Evaluation of Human Reliability Analysis Methods Against Good Practices

Final Report

**U.S. Nuclear Regulatory Commission
Office of Nuclear Regulatory Research
Washington, DC 20555-0001**

Figure 5-1. Process for Selecting and Implementing HRA Method(s) to Use

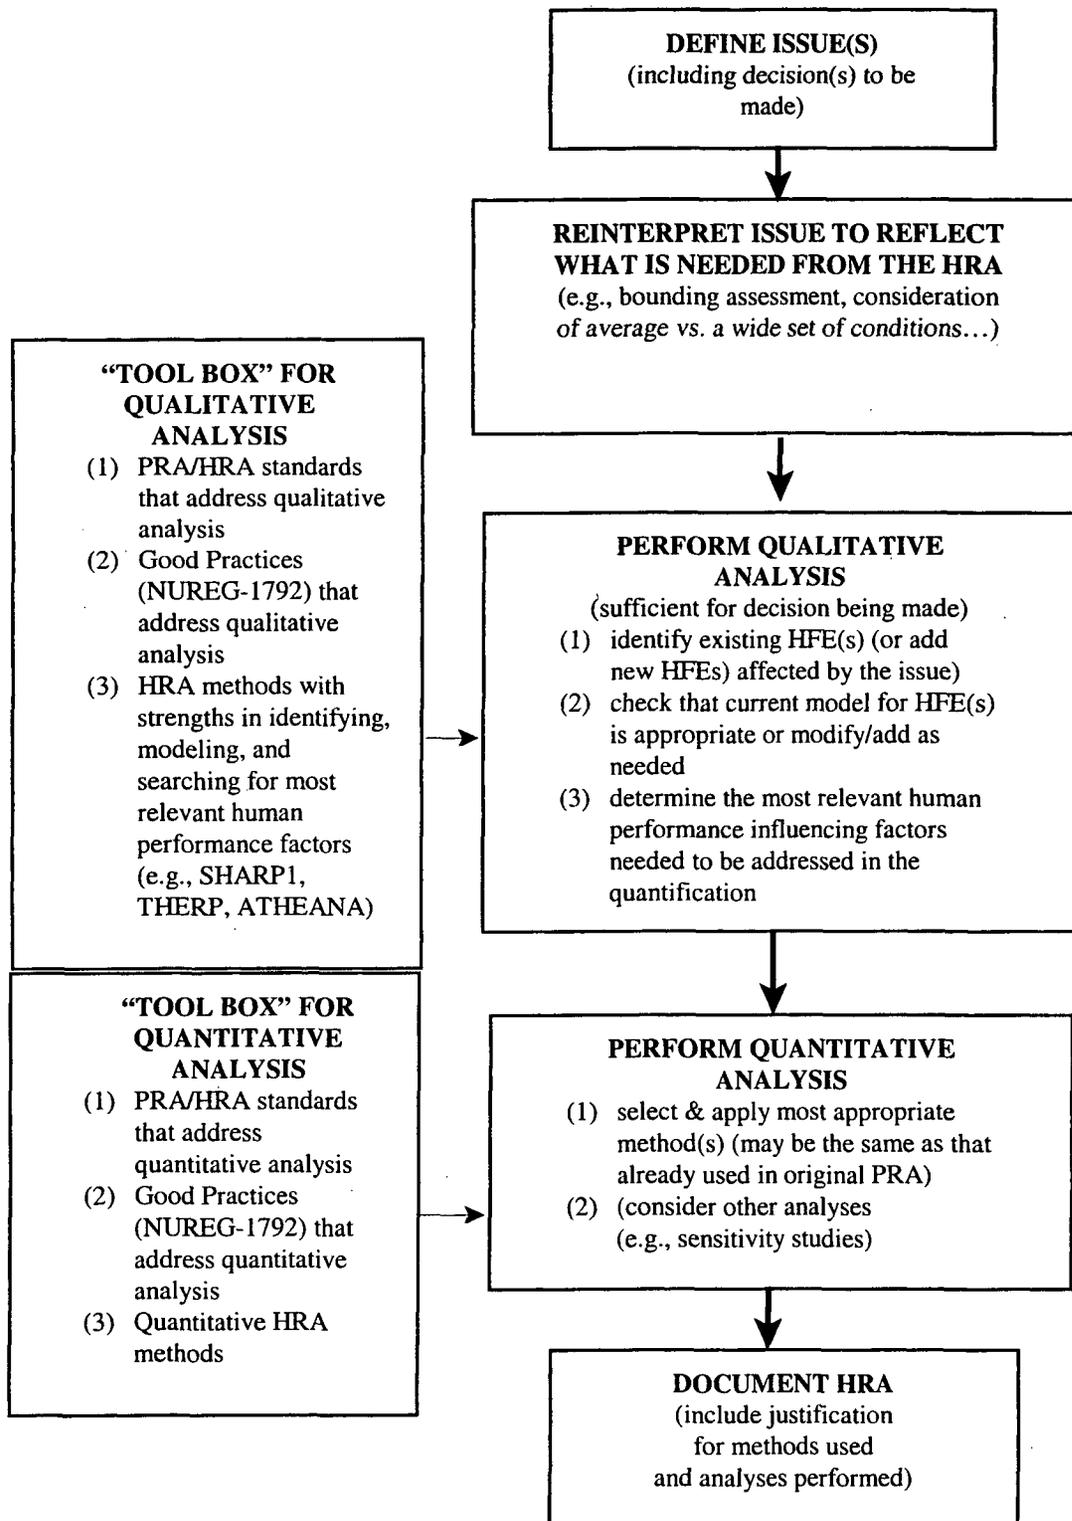
One comment related to possible concerns raised by following the flowchart provided as Figure 5-1 and the accompanying text in Chapter 5. In particular, this figure was interpreted by those making the comment that analysts need to take the best of available methods and produce a hybrid method as may be appropriate to address an application. A primary concern was that this could produce more variability in results.

The above interpretation was not the intent of Figure 5-1 or Chapter 5. In particular, the authors are not promoting that hybrid methods be created; but that a sufficient and existing method (with only slight modifications if necessary along with justification) be used.

To the extent that future applications do not or cannot make use of the general CDF/LERF results obtained in the initial PRA, but, for instance, need to determine whether a specific change is particularly sensitive to one or more human events in the PRA (or new ones that may need to be added to the PRA), and a better or different HRA is probably required to address the decision being made, then it is recommended that the overall process displayed by Figure 5-1 be followed to make the best of the available tool box of methods that exists. For instance, imagine that a specific application and corresponding decision(s) to be made is with regard to a proposed change for the layout and content of instrumentation on one or more panels. To investigate the risk impact of such a change, human-machine interface (HMI) issues will likely be particularly relevant. For this specific application, it is not helpful to use a HRA method that is incapable of adequately addressing this PSF in either a qualitative or quantitative sense, regardless of how the affected human actions were addressed in the original PRA that has its own purpose (i.e., application) of providing a general, yearly average CDF/LERF. Instead, it would be more appropriate, for this specific application, to use a method that (a) qualitatively addresses HMI as a PSF as a specific part of the method, and (b) provides quantitative guidance at a sufficient resolution to measure the effect of the proposed change in terms of the HEP(s) for the affected human action(s). It is these individual and sometimes unique uses of the tool box of HRA methods that guided what is recommended in Chapter 5. However, to the extent practicable, it is the intent that existing HRA methods be used as they are and not manipulated much beyond their existing capabilities, and certainly not that hybrid methods should be created.

Clarifications regarding the intent of Figure 5-1 have been provided in the document along the lines of the explanation provided here.
